**Addendum #04  
June 8, 2023  
IFB 23-B0048  
Myrtle Beach World War II Memorial**

The purpose of this Addendum #04 to IFB 23-B0048 for Myrtle Beach World War II Memorial, dated April, 2023, and previously amended on May 11, 2023; May 25, 2023; and May 31, 2023 is to clarify the bid documents.

WORLD WAR II  
MEMORIAL

1 TRASH RECEPTACLE  
NTS

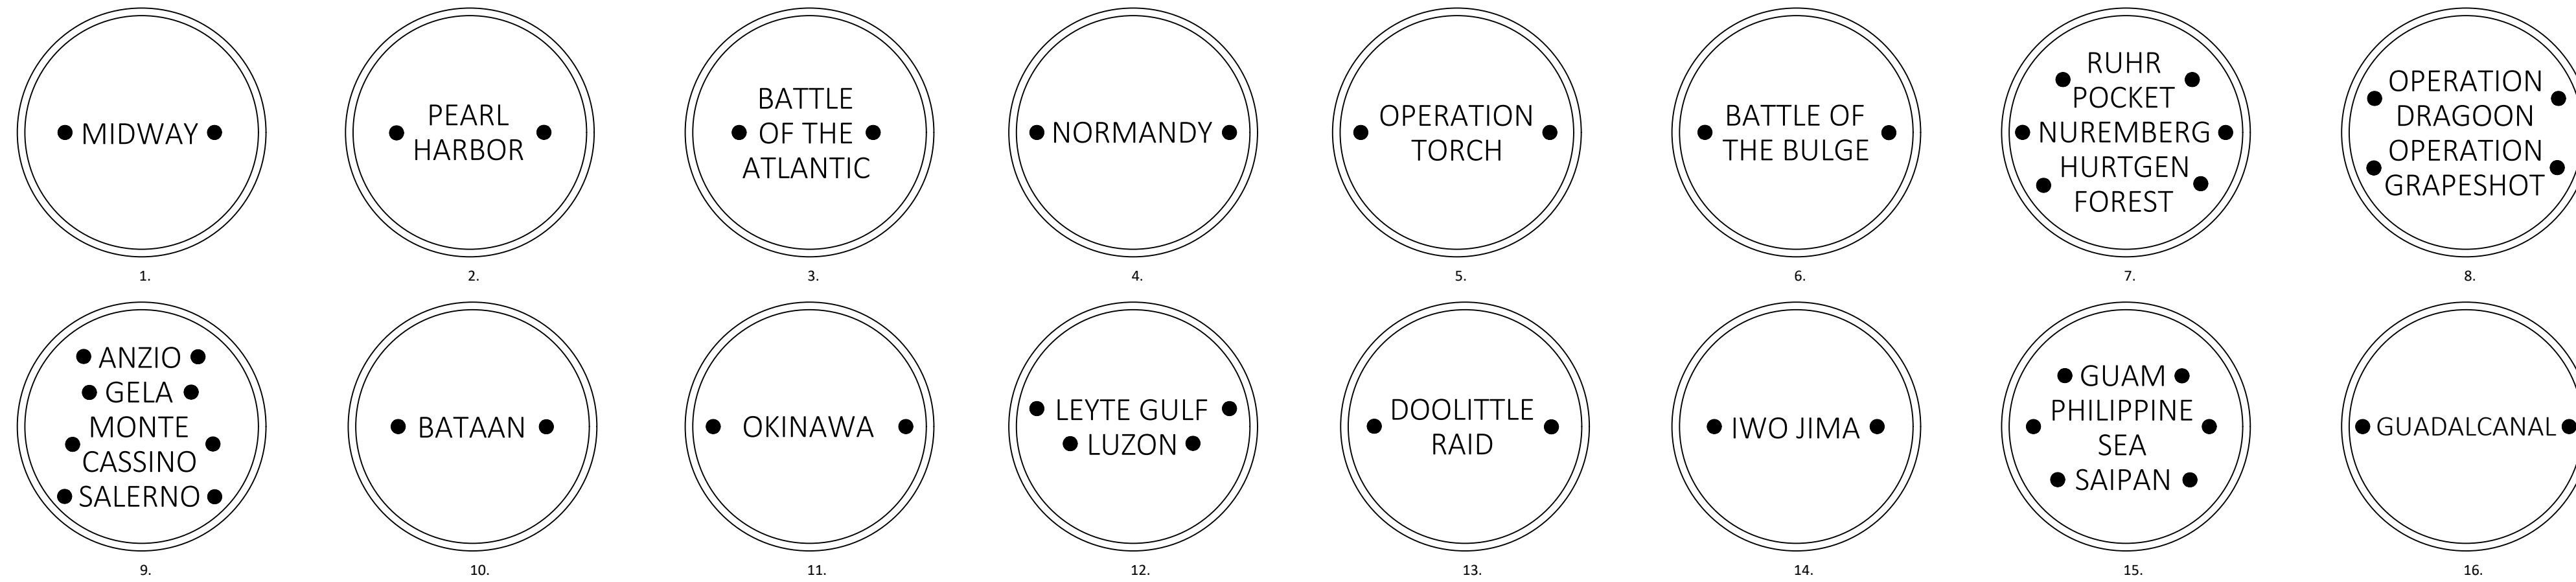
- 1.01 Confirmed quantities for bronze plaques and medallions are as follows: (3) bronze plaques and (16) medallions. Refer to Sheet C2.05.
- 1.02 Trash receptacles representative is as follows: Lauren Wilson at Anova Furnishings (314-755-1264). Trash receptacle with City of Myrtle Beach logo shall match existing trash receptacles previously procured by the City. Vector image required shall be provided by Engineer upon award of contract.

L1.01

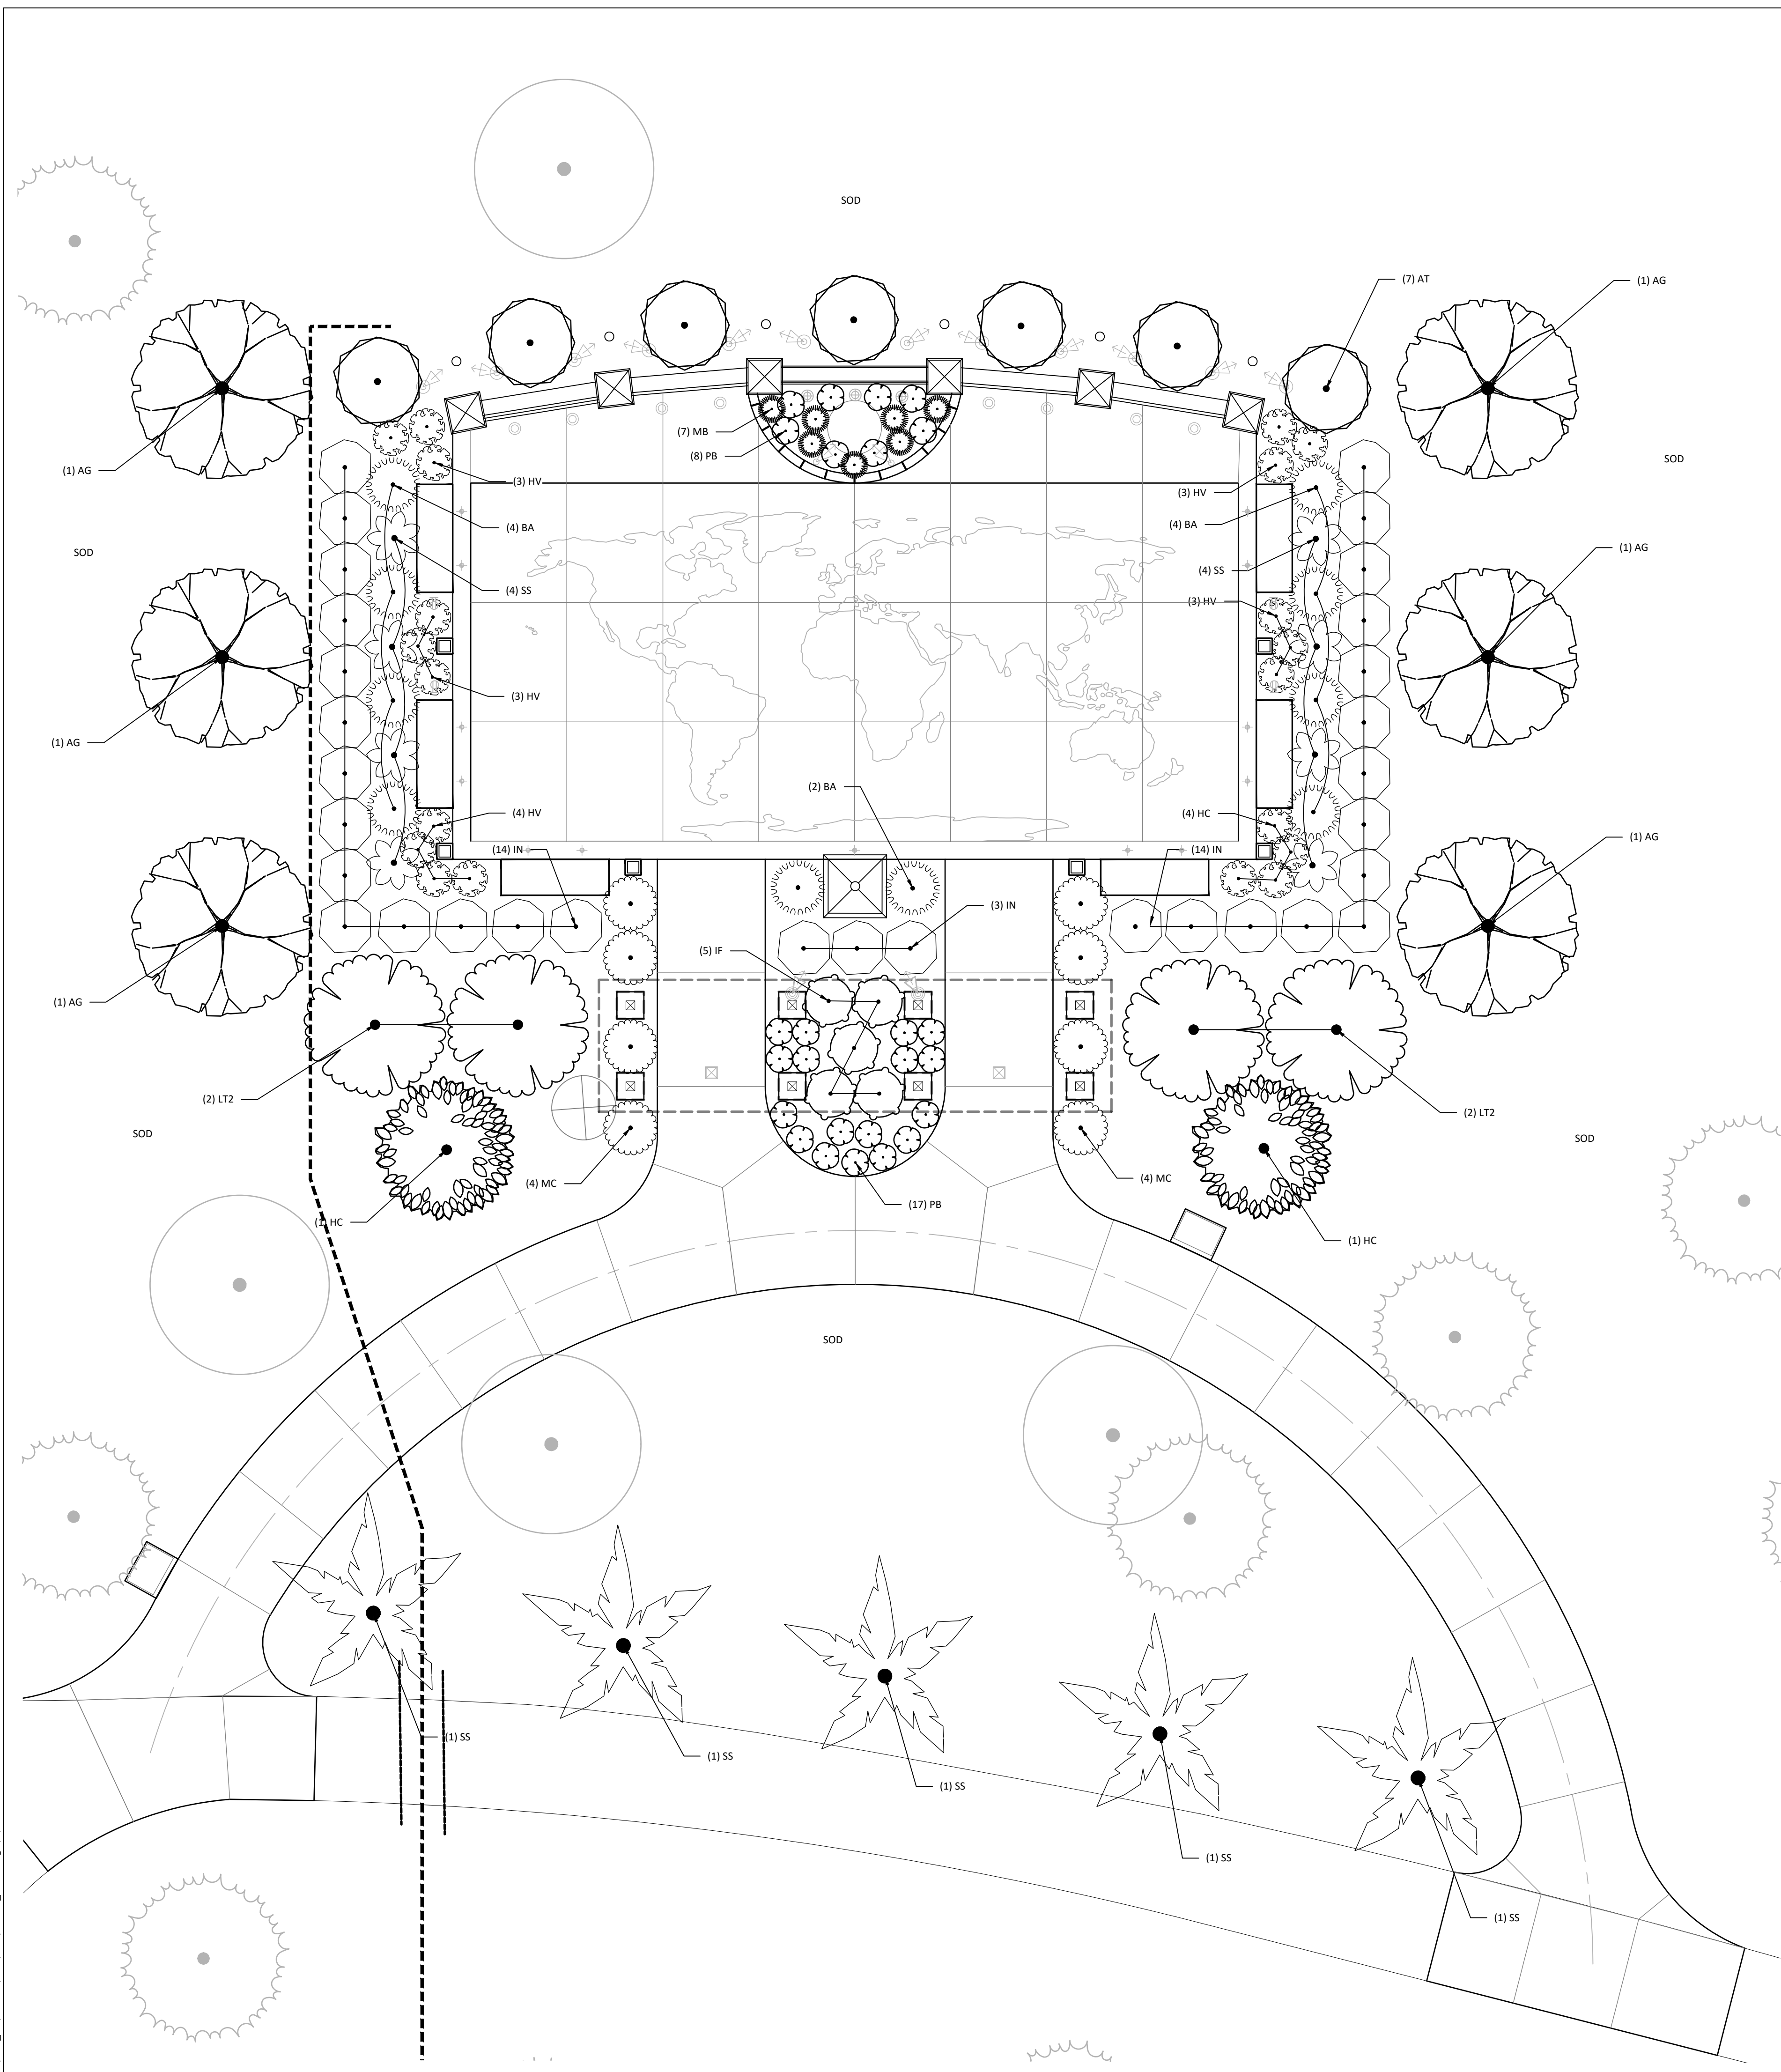
1. **REPLACE** Sheet L1.01 – Landscape Plan in its entirety with attached revised sheet. Previously labeled symbol TC has been updated to HV.
